Project	IEEE 802.16 Broadband Wireless Access Working Group < http://ieee802.org/16 >	
Title	RS network entry procedure	
Date Submitted	2007-03-10	
Source(s)	<p>Mike Hart, Yuefeng Zhou, Sunil Vadgama Fujitsu Laboratories of Europe Ltd. Hayes Park Central Hayes, Middx, UB4 8FE, UK</p> <p><u>Sungjin Lee, Hyunjeong Kang, Hyoungkyu Lim</u> <u>Samsung Electronics</u></p>	<p>Voice: +44 20 8606 4523 Fax: +44 20 8606 4539 mike.hart@uk.fujitsu.com</p> <p>Voice: +82 31 279 5248 Fax: +82 31 279 5130 E-mail : steve.lee@samsung.com</p>
Re:	Call for technical proposals 802.16j-076/007r234	
Abstract	<p>This contribution provides a technical proposal for the RS network entry procedure for the case of a non-transparent RS. It is based on reusing many of the stages executed in the SS network entry procedure with the only major change being the introduction of new SBC and REG TLV values to enable exchange of information about PHY & MAC features supported by the RS. It also defines how the RS switches from using the access link to using the relay link following successful registration with the MR-BS.</p>

RS network entry procedure

Mike Hart, Yuefeng Zhou, Sunil Vadgama
Fujitsu Laboratories of Europe

Fig. xxx RS initialization overview

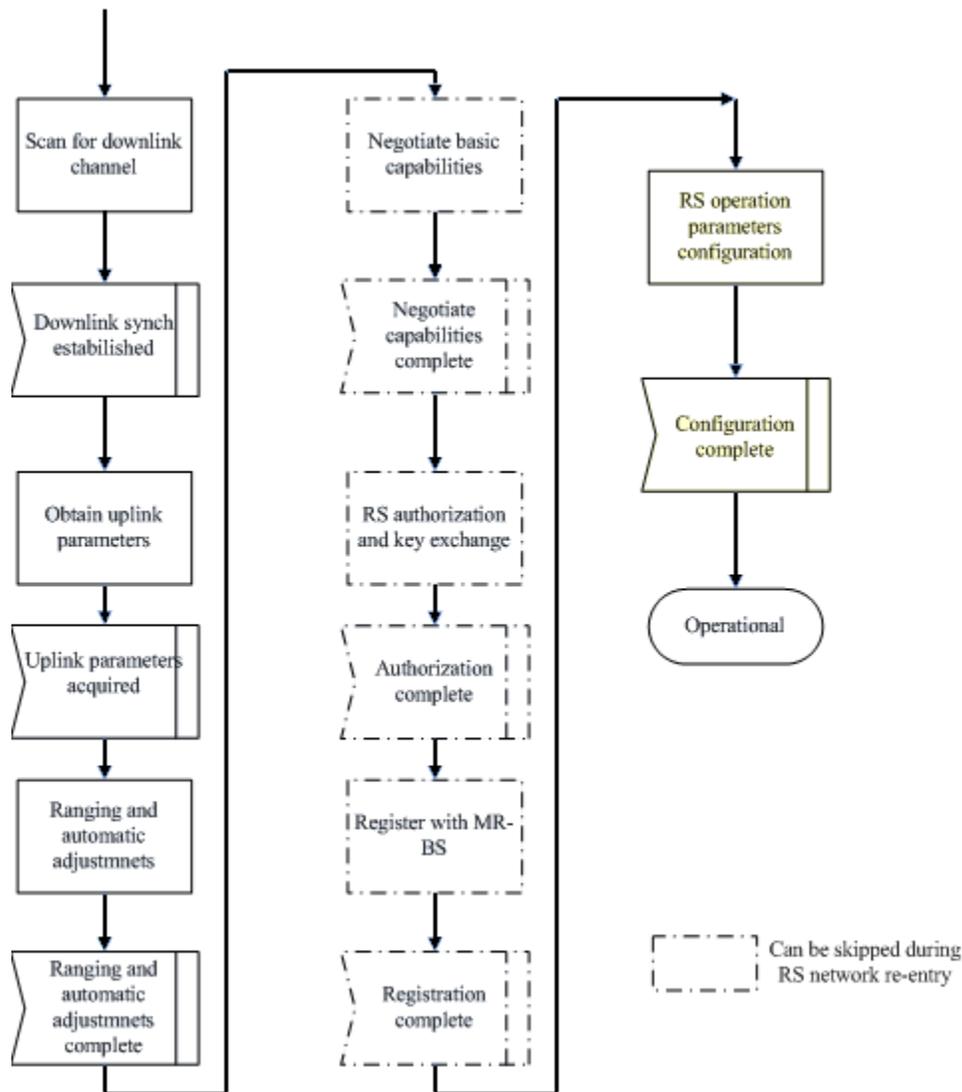
The procedure for initialization of an RS shall be as shown in Figure xxx55. For the RS the stages ~~e)~~, g), h), i) and j) in the figure 55 are not required, for all other stages the RS shall behave in the same manner as an SS during network entry unless otherwise specified in the subclauses of 6.3.9. The more detailed finite state machine representations of the individual sections (including error paths) and the timeout values shall be the same as those provided for the SS, unless otherwise specified.
